<b>KORFF + CO.KG</b> Luftfahrttechnischer Betrieb LBA II-A 189 Dieselstrasse 5 D-63128 Dietzenbach/GERMANY	<b>SERVICE  BULLETIN  SB-KOCO 05/818</b>	TAIFUN 17E
		AUSGABE 01 ISSUE

**Subject:** *Inspection and eventual replacement of central bolt of wing locking mechanism, inspection of telescopic rods*

<b>KORFF + CO.KG</b> Luftfahrttechnischer Betrieb LBA II-A 189 Dieselstrasse 5 D-63128 Dietzenbach/GERMANY	<b>WORK- INSTRUCTION</b> <b>AW-KOCO 05/818</b>	TAIFUN 17E
		AUSGABE 01 ISSUE

Part of drawing F1-1319 "Zentralbolzen" (Front view)  
**Attention: Part of drawing not in scale !!!**

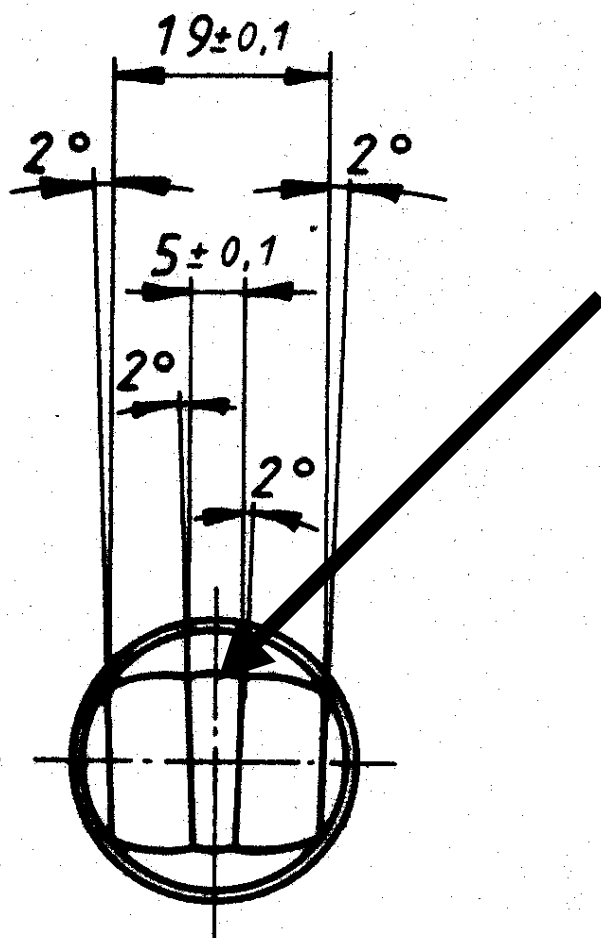
- Find out install direction of central bolt according to part of drawing F1-1319 "Zentralbolzen" (Front view) and part 1 of drawing F1-1343 "Flügelverriegelung".

Wide side of cone (5 mm +/- 0,1) - see arrow - has to be mounted to the **top**.

Part 1 of drawing F1-1343 "Flügelverriegelung".  
**Attention: Part of drawing not in scale !!!**

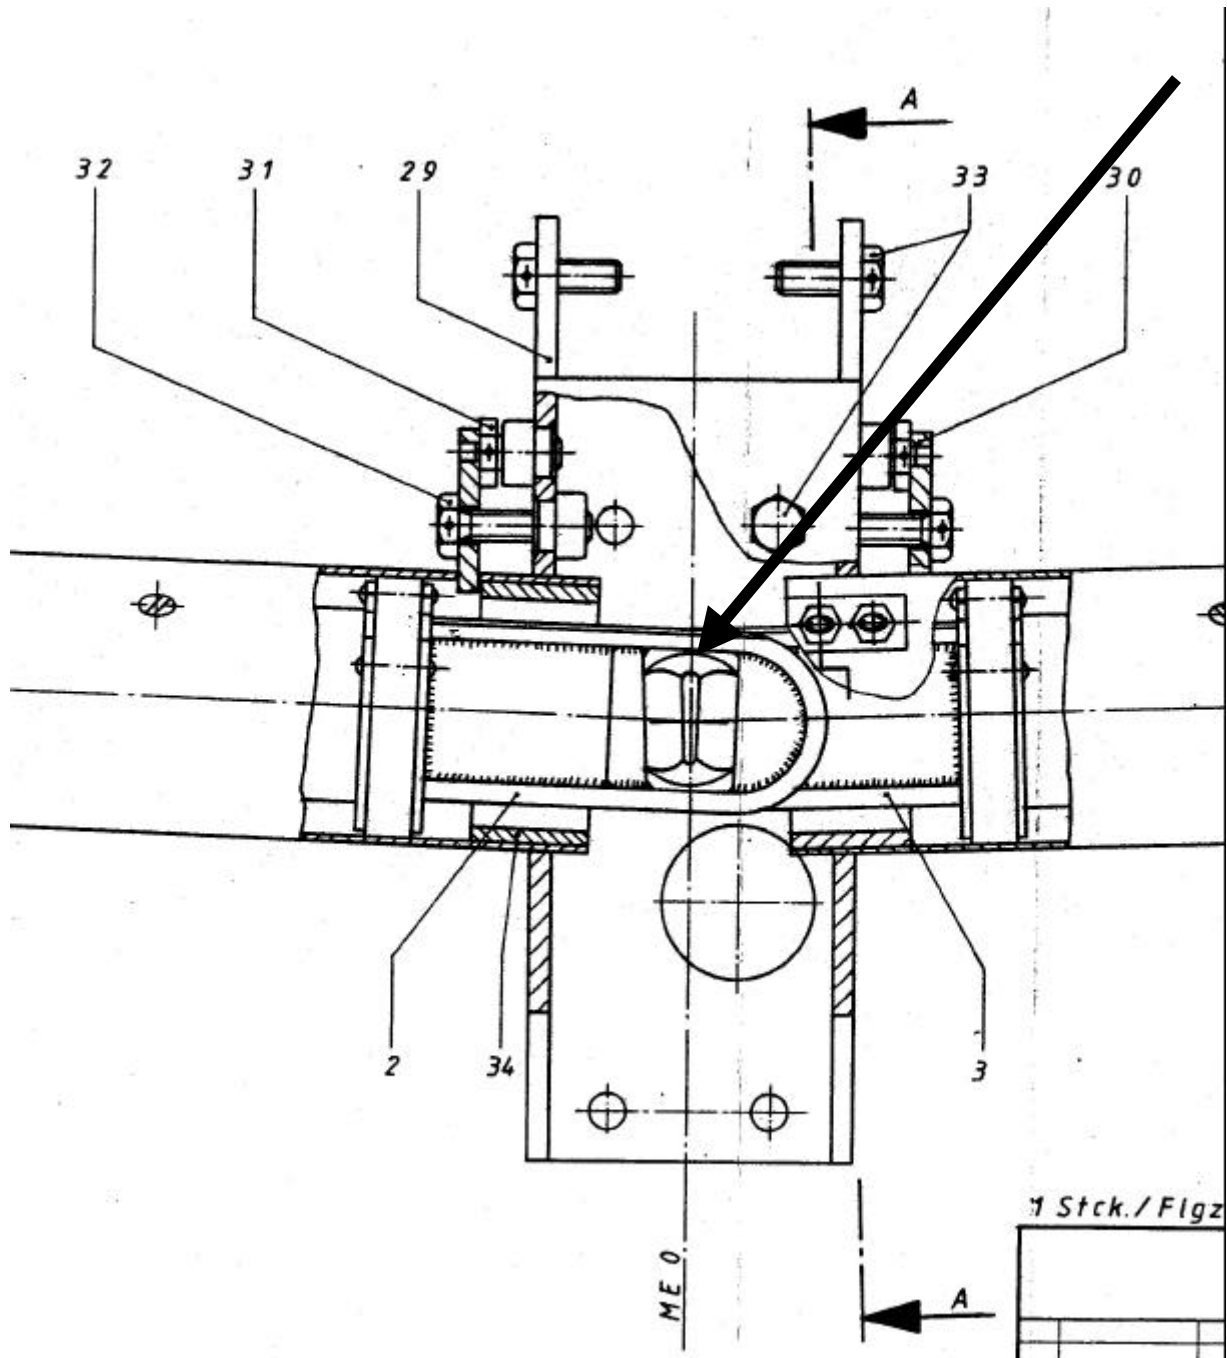
Use caution to install the bolt with the wide side of the cone to the top - see Part 1 of drawing F1-1343 "Flügelverriegelung" and Part of drawing F1-1319 "Zentralbolzen" (Front view).

Part of drawing F1-1373 "Zentralbolzen Fertigteil"

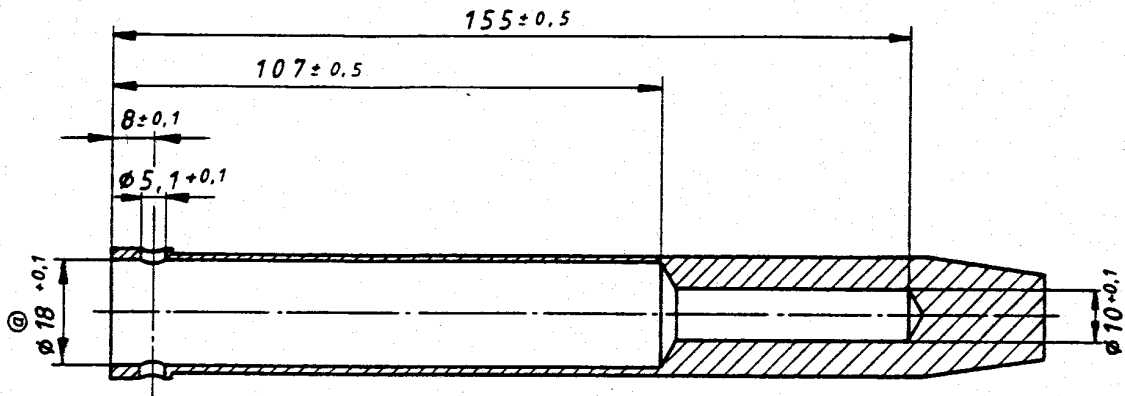
- Visual inspection of cylindrical, hollow part of central bolt for cracks with magnifying glass (magnification 5 times) , see part of drawing F1-1373 "Zentralbolzen Fertigteil"
- Central bolts with cracks have to be replaced immediately !
- Central bolts referring to Amendment "a" without cracks have to be replaced by central bolt referring to drawing dated 24.11.82 latest 31.03.2001.

Part 2 of drawing F1-1343 "Flügelverriegelung"

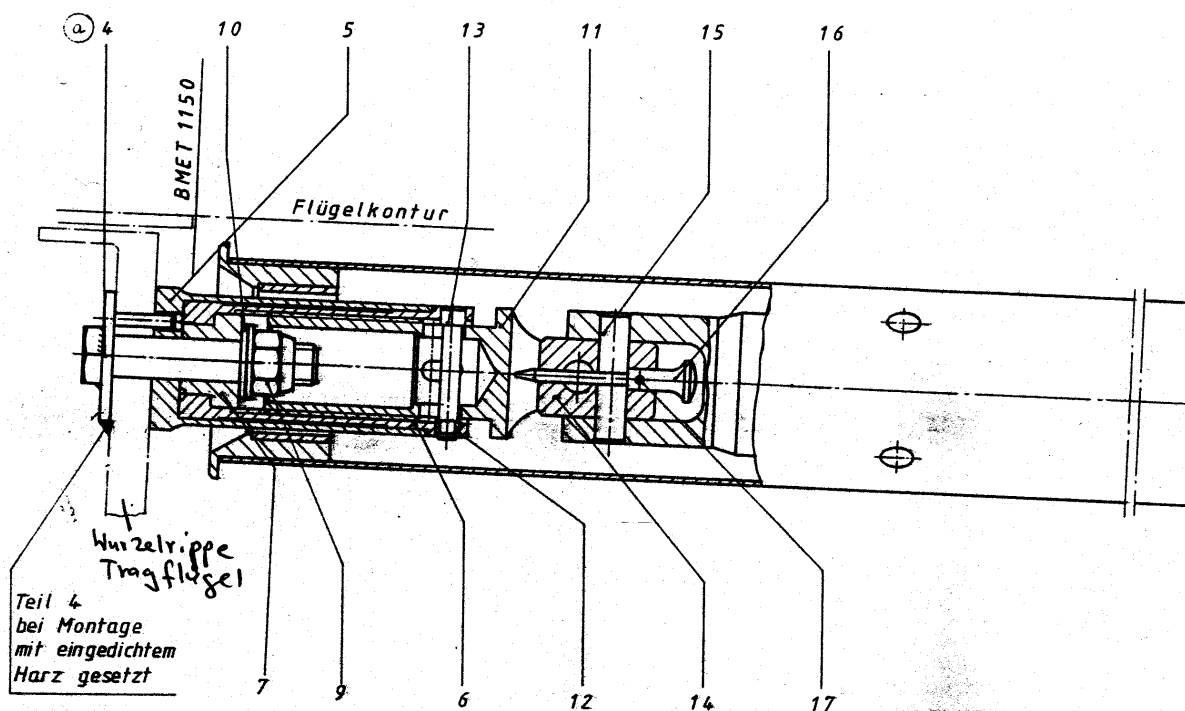
- Clean up both ends of locking mechanism (fig. 2 and 3 of part 2 of drawing F1-1343 "Flügelverriegelung") and inspect flanks by endoscope for cracks or deformation caused by probably wrong installation direction of central bolt.

- Visual inspection of connection of telescopic rods to the wings and to the GRP of both wing root ribs for cracks with magnifying glass (magnification 5 times) , see part 2 of drawing F1-1343 "Flügelverriegelung".
